SYSTEM IMPACT ASSESSMENT REPORT

*For the incorporation of a new 500kV double-circuit
line between the Bruce Complex & Milton TS*

Applicant: Hydro One Networks Inc.

CAA ID No. 2006-250

DIAGRAM 2

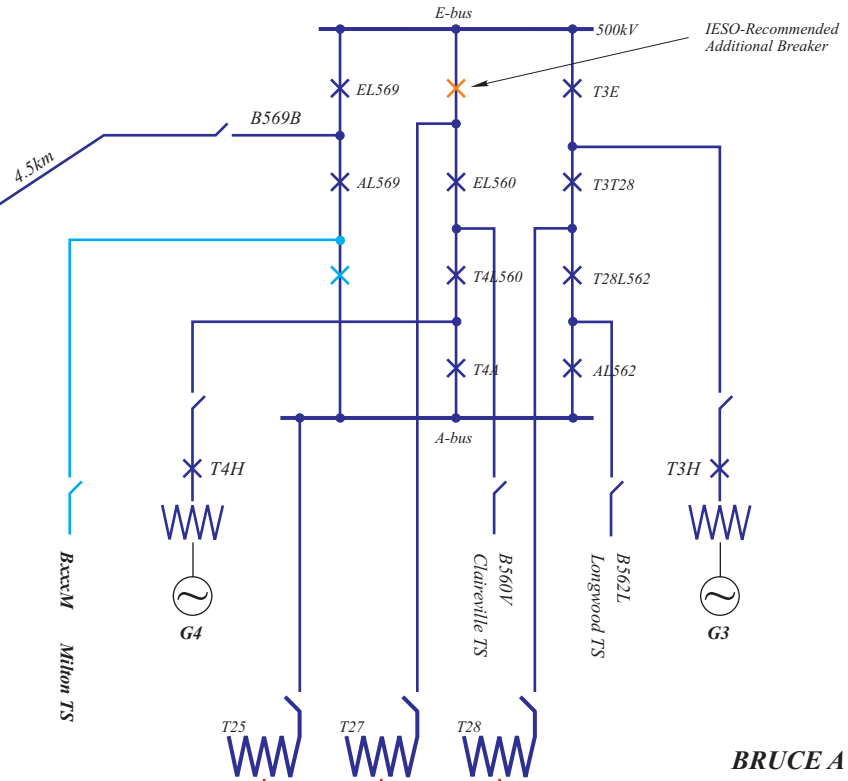
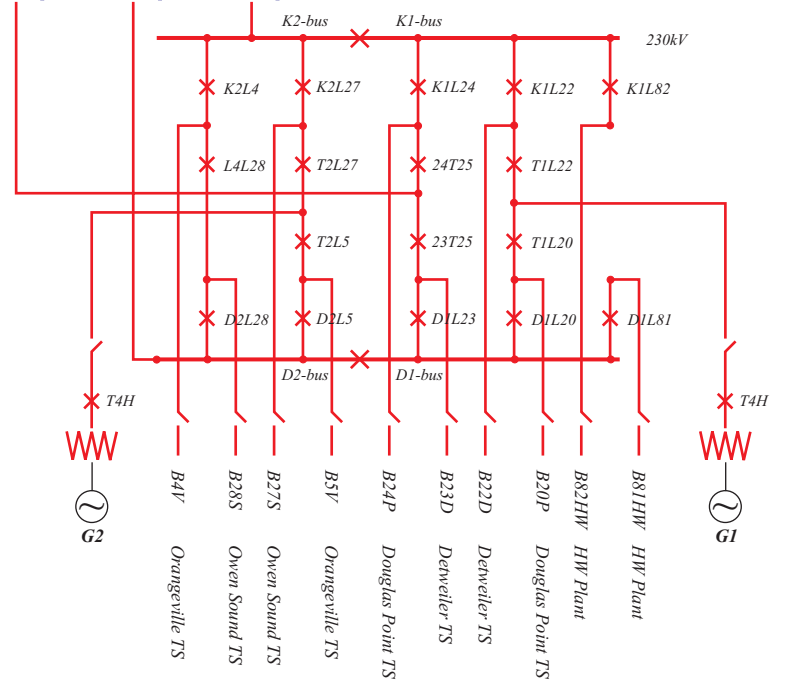
A further 500kV breaker has also been shown in the middle diameter of the 500kV Bruce A switchyard.

Since a failure of the 500kV breaker EL560 would result in the simultaneous loss of both the E-busbar and the existing 500kV circuit B560V to Claireville TS, this situation can result in both generating units at the A-station being isolated on to the 500kV circuit to Longwood TS whenever breaker AL569 is out-of-service. This will also apply to future outages involving the new breaker that it is proposed to install in the switchyard of the A-station for the termination of the new circuit to Milton TS. Under these outage conditions, transient stability limitations would require the output of the two generating units at the A-station to be restricted.

The IESO therefore suggests that consideration be given to the installation of the additional 500kV breaker at the A-station to avoid the loss of the E-busbar at this switchyard in response to a breaker-failure condition involving the breaker EL560.

Proposed Additions to the Milton 500kV Switchyard for the termination of the two new 500kV circuits to the Bruce Complex

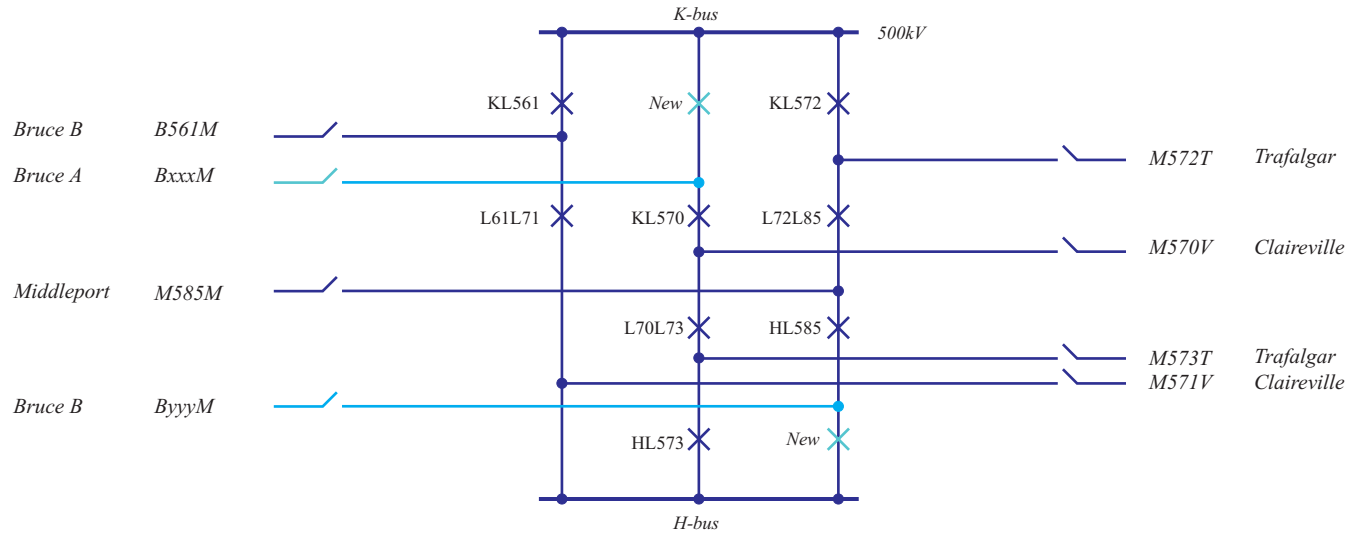
It is therefore recommended that the proposed layout of the 500kV busbar at Milton TS be reviewed to avoid the simultaneous loss of the 500kV circuit M573T and either of the 500kV Milton-to-Claireville circuits due to a breaker-failure condition involving either of the 500kV breakers L70L73 or HL573.

DIAGRAM 9
 24th March 2007

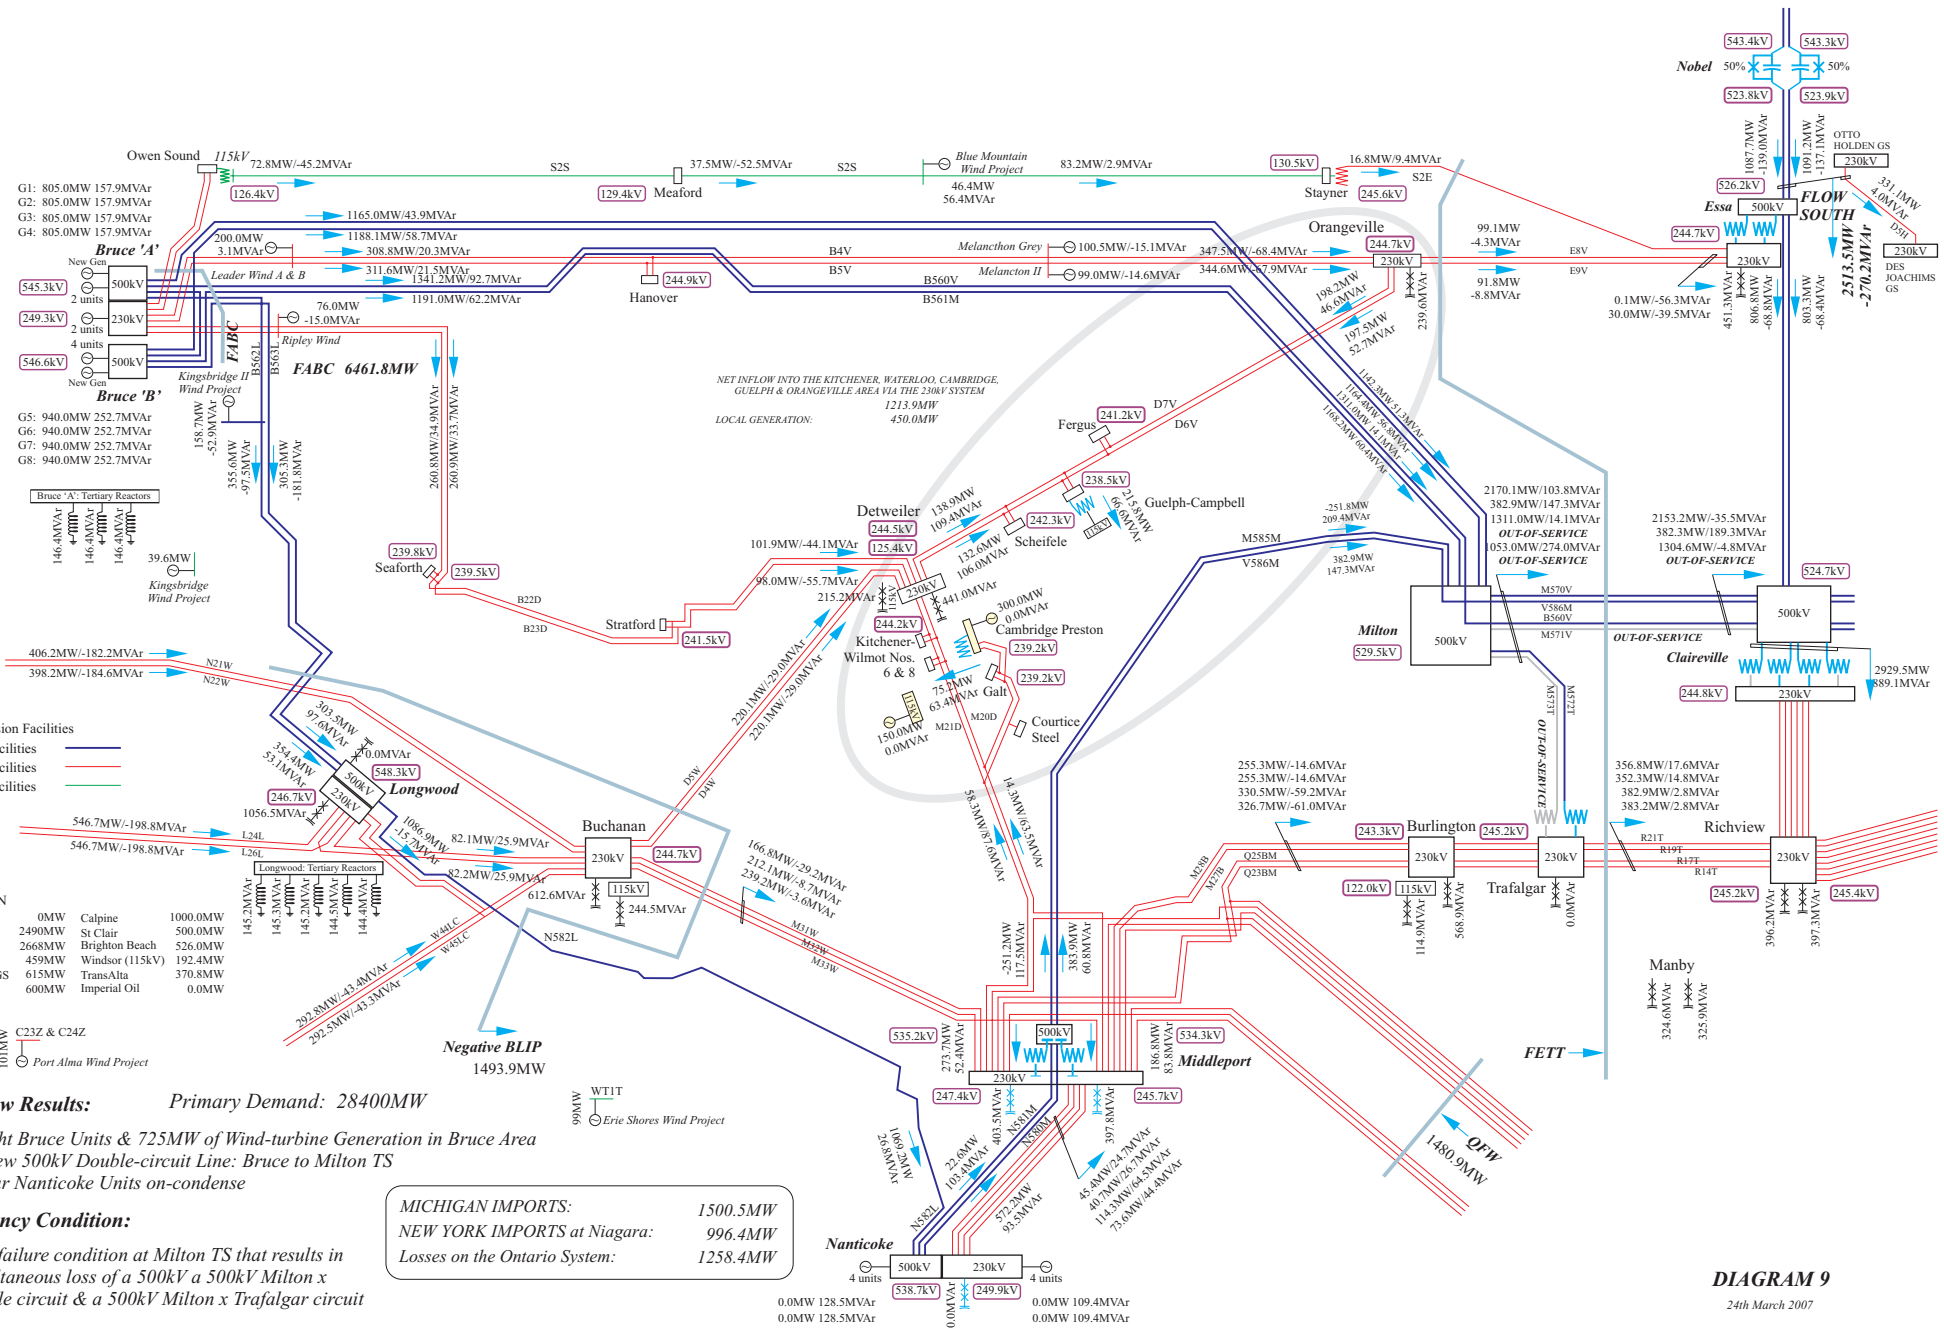
The results for this contingency condition have been summarised in Diagram 9 and these show that the transfers through the T14 unit that would remain in-service connected to circuit M572T post-contingency (1088MVA), would be only marginally within its 10-day long-term emergency rating of 2625A or approximately 1090MVA.

DIAGRAM 10

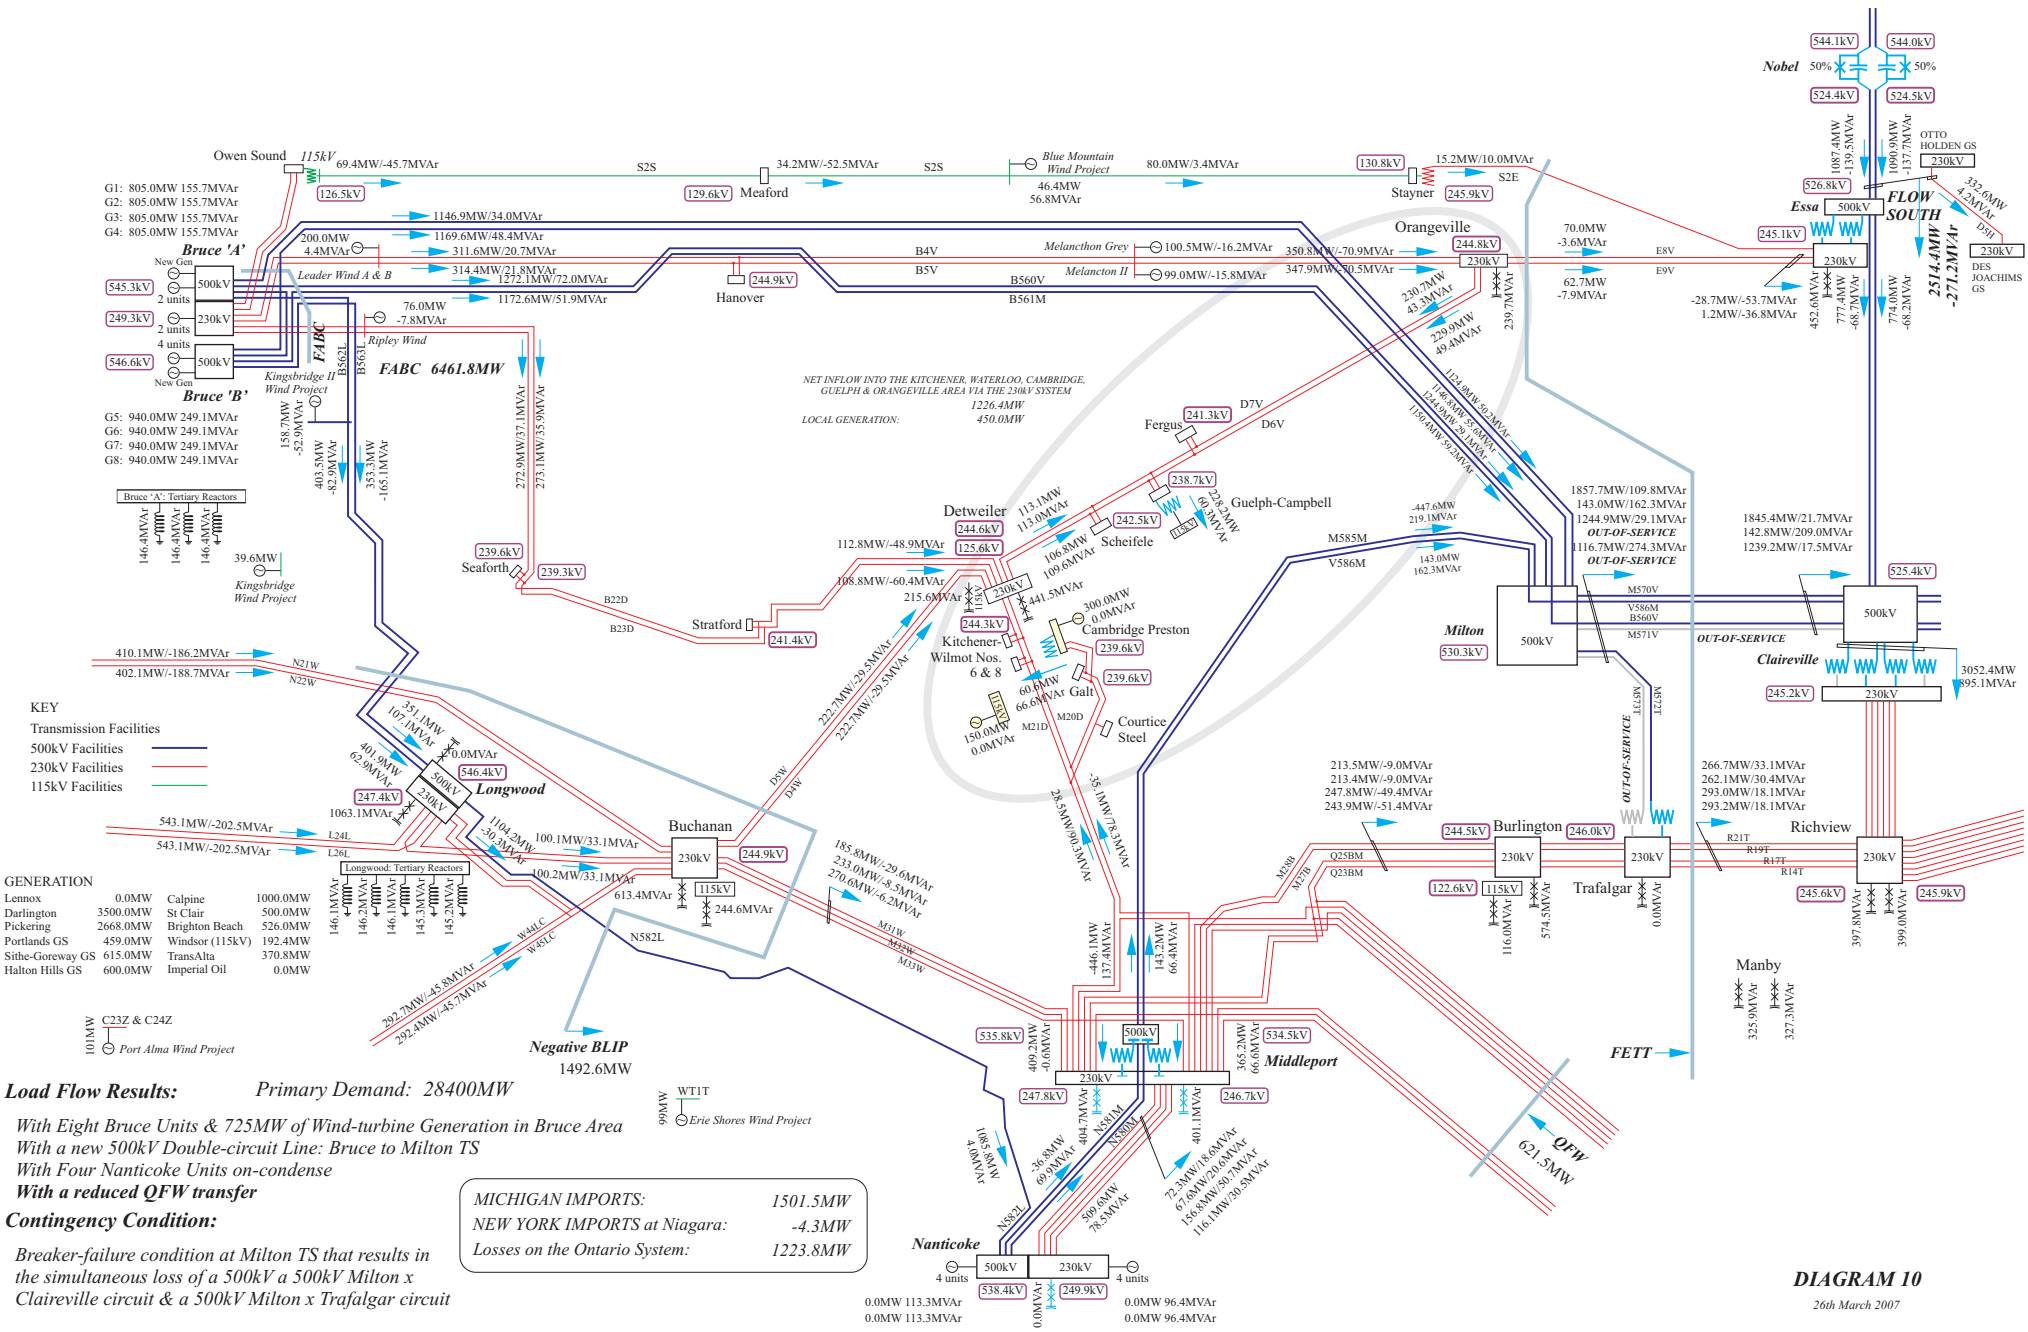
Diagram 10 shows the results for the same contingency condition but with a reduced transfer across the QFW Interface. These results show that the 10-day long-term emergency rating would be exceeded. Similar results would be expected for the condition with a reduced transfer across the Negative-BLIP Interface.

DIAGRAM 18
 24th March 2007

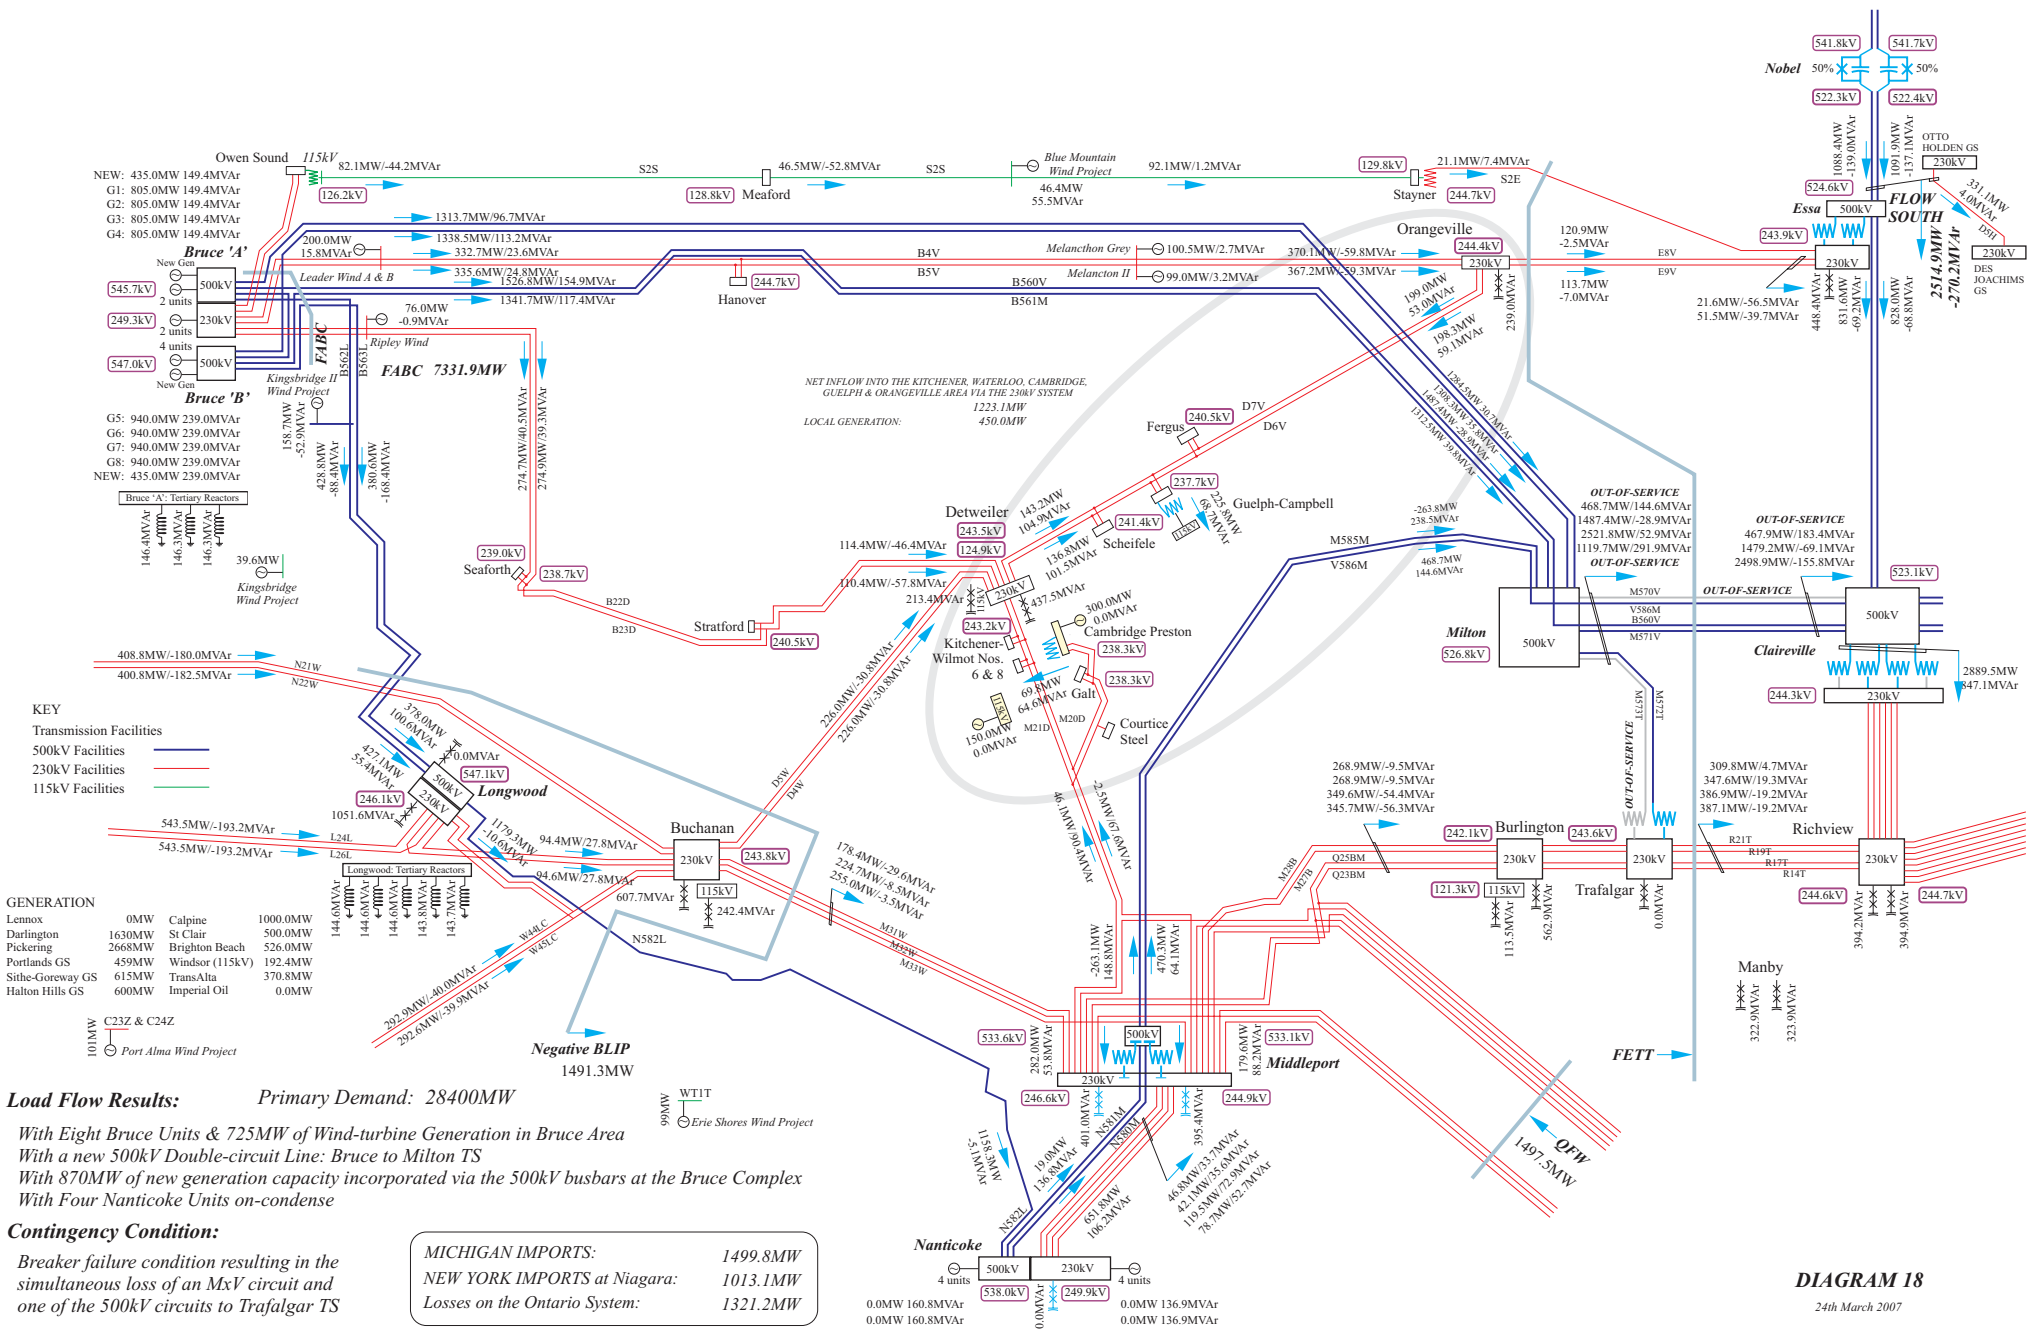
Diagram 18 shows the results from this study. These show a post-contingency transfer of approximately 1160MVA through the remaining 500/230kV auto-transformer at Trafalgar TS, which would exceed its 10-day limited-time-rating of 1090MVA.

The recommendation to review the proposed layout of the 500kV busbar at Milton TS so as to avoid the simultaneous loss of the 500kV circuit M573T and either of the 500kV Milton-to-Claireville circuits due to a breaker-failure condition involving either of the 500kV breakers L70L73 or HL573, would therefore be even more relevant with the added generation capacity.
